International Aero Engines

V2500-A1/A5 PROPULSION SYSTEM SERVICE BULLETIN

This document transmits Revision 1 to Service Bulletin EV2500-72-0176

ENGINE - HP COMPRESSOR - INTRODUCTION OF A HP SYSTEM MODULE SERIAL NUMBER
IDENTIFICATION PLATE

Location of identification plate and bracket
Fig.1

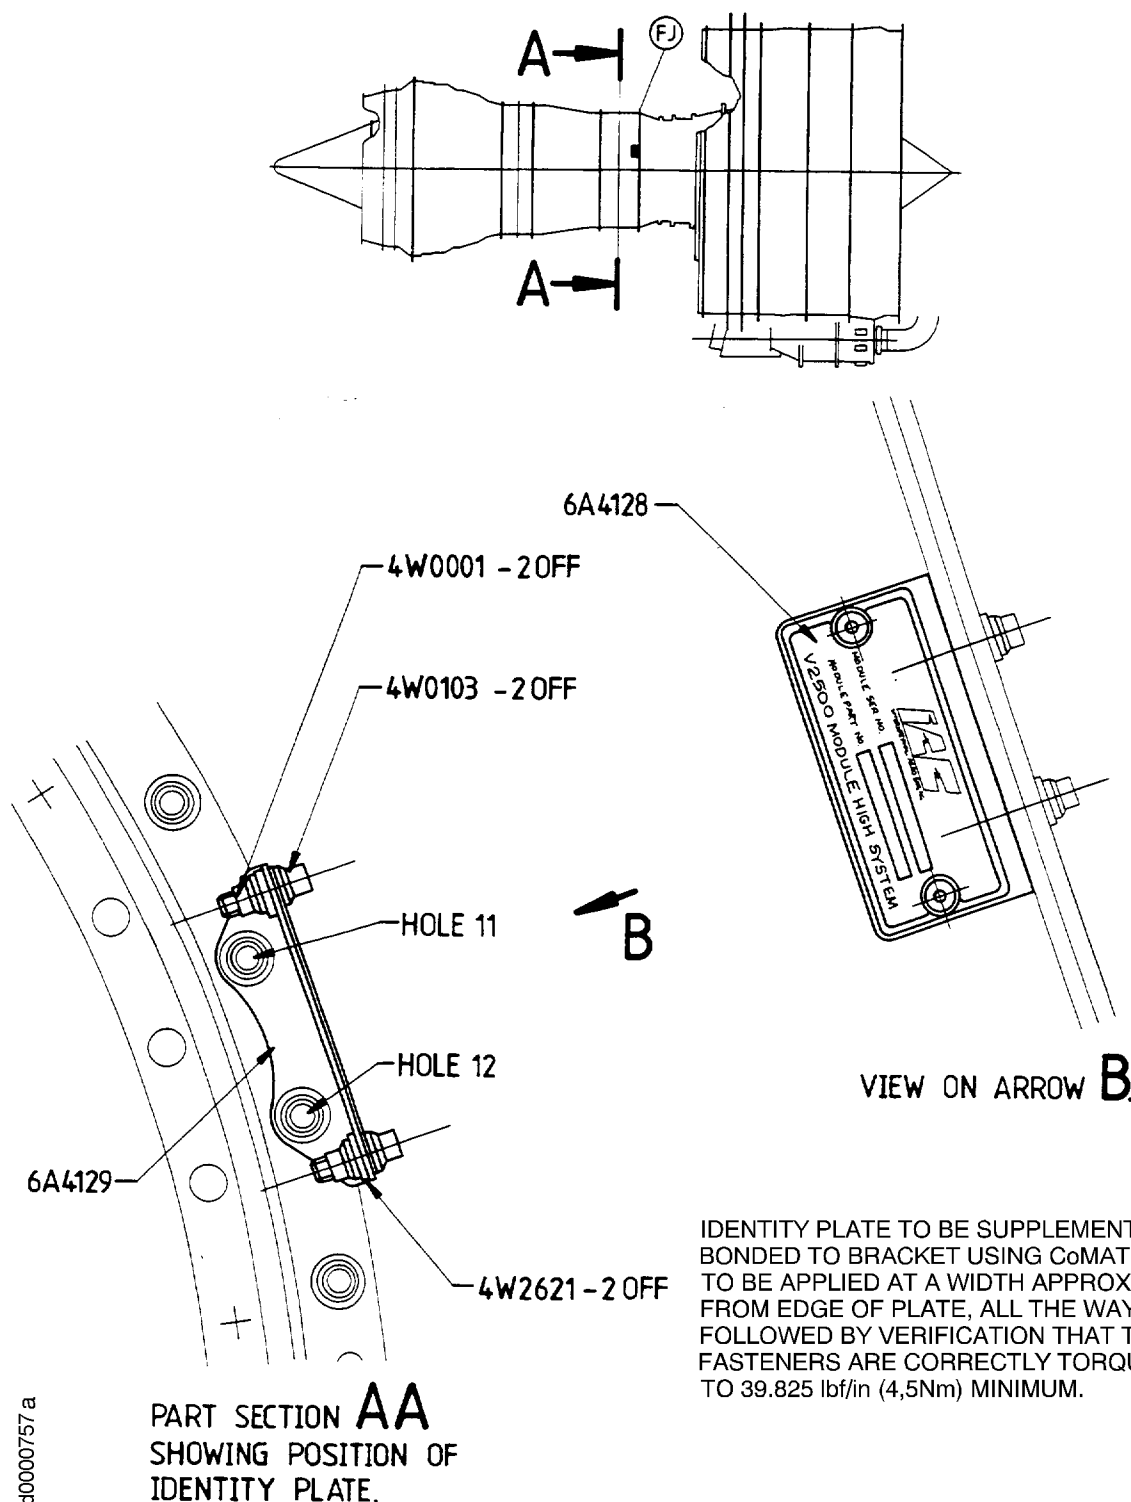
Reason for change
Correction to torque
loading figure in 3.B.
Assembly Instructions

- (1) Machine engrave the HP System Module Serial and part numbers on the 6A4128 identification plate in the spaces provided in accordance with References (1), TASK 70-09-00-400-501, SUBTASK 70-09-00-400-001.
- (2) Apply CoMat 08-013, Cold Curing Silicone Compound, to the 6A4128 identification plate and bond the plate to the 6A4129 bracket as shown in Figure 1 and in accordance with Reference(1), TASK 70-36-02-360-501, SUBTASK 70-36-02-360-020.
- (3) Secure the plate with the 4W0103 bolts, 4W2621 washers and 4W0001 nuts. Torque the bolts to 39.8 lbfin (4,5 Nm) minimum.
- (4) Install the plate and bracket onto the rear face of flange FJ at the position shown in Figure 1 using the existing nuts and bolts. Torque the bolts to 180 to 220 lbfin (20 to 25 Nm).

IDENTITY PLATE TO BE SUPPLEMENTARY BONDED TO BRACKET USING CoMAT 08-013, TO BE APPLIED AT A WIDTH APPROX 10mm FROM EDGE OF PLATE, ALL THE WAY AROUND FOLLOWED BY VERIFICATION THAT THE FASTENERS ARE CORRECTLY TORQUED TO 39.825 lbf/in (4.5Nm) MINIMUM.
